# Access Compliance Report

## Public Rights-of-Way

### (Curb Ramps)

| Intersection ID: 48160 | Main Street: NORTHLAKE CENTRE PY | Cross Street: N/A       | Location: NE           |

| ADA ID: 90436C02DF6A   | Ramp Type: Perp                  | Initial Pass/Fail: Fail | Overall Compliance: No |

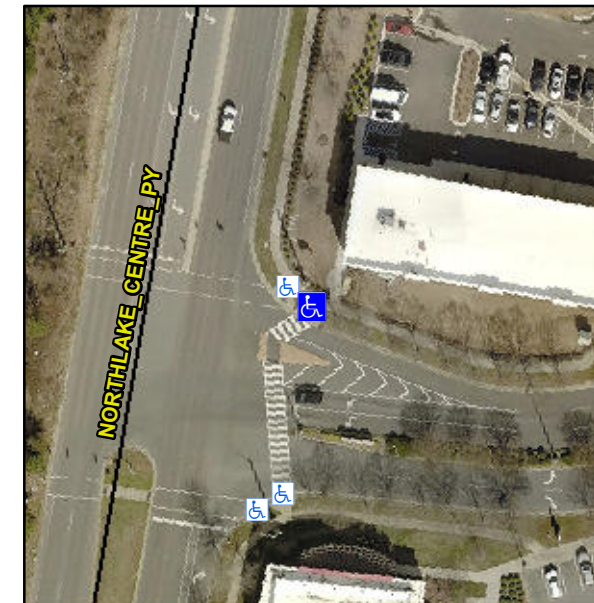
**Not Found, R304.5.1, R304.5.3**

| Compliance | Description           | Data  | Compliance | Description                 | Data |
|------------|-----------------------|-------|------------|-----------------------------|------|
| No         | Ramp Width (in)       | 46.5  | No         | Ramp XSlope (%)             | 3.1  |

**Remove & Replace Entire Ramp.**
